April 10, 2018

**Re: Case No. 17ZONE1031
Opposition to Application for Zone Change Amendment,
Variance, and Waiver at
1576 Cherokee Road, Louisville, Kentucky 40205**

Figure 1 The Applicant's own drawings demonstrate the massive scale and bulk of the proposed building. For comparison, see the single-family home just North of the proposed building, and all the other homes in the area.

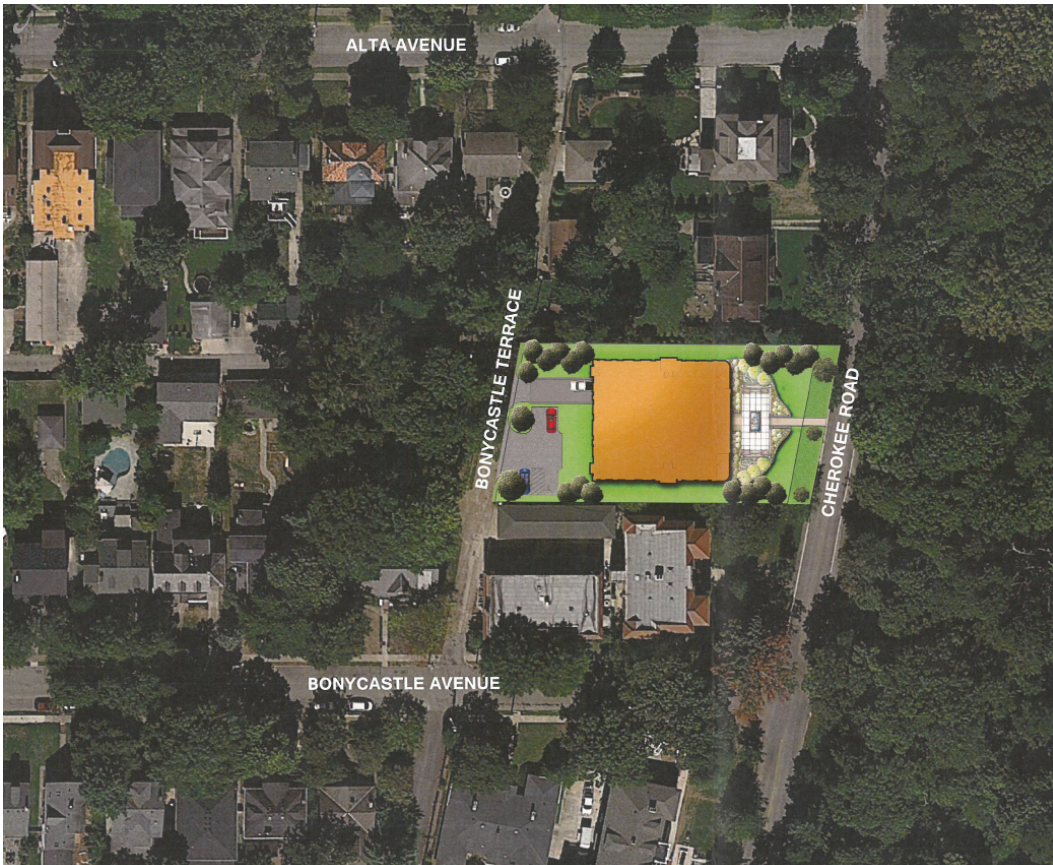
Euclidian Zoning in Jefferson County. It will tower over by more than thirty feet all but one building in the area. The building will have almost double the depth of most of the buildings in the area. The scale, bulk, height, and depth of the building is incompatible with the Comp Plan, the Neighborhood Plan, and the character of the neighborhood. To combat this incompatibility, the Developer included a list with their application titled "Multi-family Building Heights and Footprints in Bonnycastle and Cherokee Triangle." That list included seven buildings with heights ranging from 53 ft to 214 feet. All but three of these buildings are located outside of the Bonnycastle neighborhood. Those three are the Commodore Condominiums at 2140 Bonnycastle Avenue, 1611 Spring Drive, and Park Grande at 1604 Cherokee Road. The Commodore was built before Louisville adopted planning and zoning regulations. 1611 Spring Drive was built in 1972 and is only 54 feet tall. Park Grande, although somehow granted a variance to allow it height of 112 feet, is still zoned R-7 and still maintains a FAR equal to or less than 1.0. Still, because of the precarious history of that development, it should not be used as a precedent here. This list actually compounds and supports the Neighbors' concerns - that building of this scale, bulk, and height do not exist, and the buildings that are, within the neighborhood, were approved before planning and zoning regulations were adopted by the city.

The other four buildings cited by the Applicant are outside of the boundaries of the Bonnycastle neighborhood. Nevertheless, the development histories of those buildings speak for themselves, especially 1400 Willow, which was finally completed more than 20 years after it was initially proposed in 1958. Furthermore, all but two of these seven buildings are located on street corners, which are more conducive to high density and high bulk developments. However, the proposed development is located in the middle of the block squeezed between a much smaller single family and condominium building.

Figure 2. The proposed development would be the only R-8A zoning in the area, and would be surrounded by R-5 properties with the exception of the Southwest neighbor on Cherokee Road.

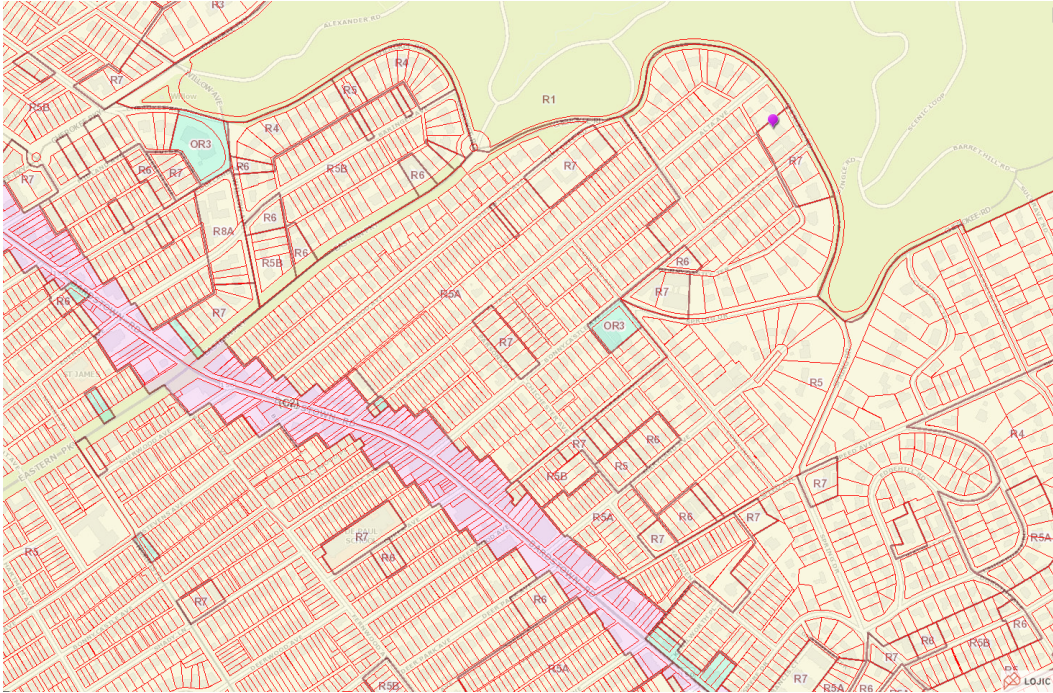
Spot zoning is “generally frowned upon by the courts.” *Mathis v. Hannan*, 306 S.W.2d 278, 280 (Ky. 1957). If the zone map amendment is granted, this parcel will be the only R-8A zoned property in the area, and will be surrounded by R-5 zoning on all sides except for one. In fact, with the exception of the property to the Southeast, which is zoned R-7, the rest of the immediate area is zoned R-5. Moreover, the proposed development is not contiguous with any other property of this density, height, and bulk. Comprehensive Plans, neighborhood plans and zoning codes, including those that apply here, are designed to prevent this type of spot zoning. The applicant has set forth no reason to deviate from these requirements.
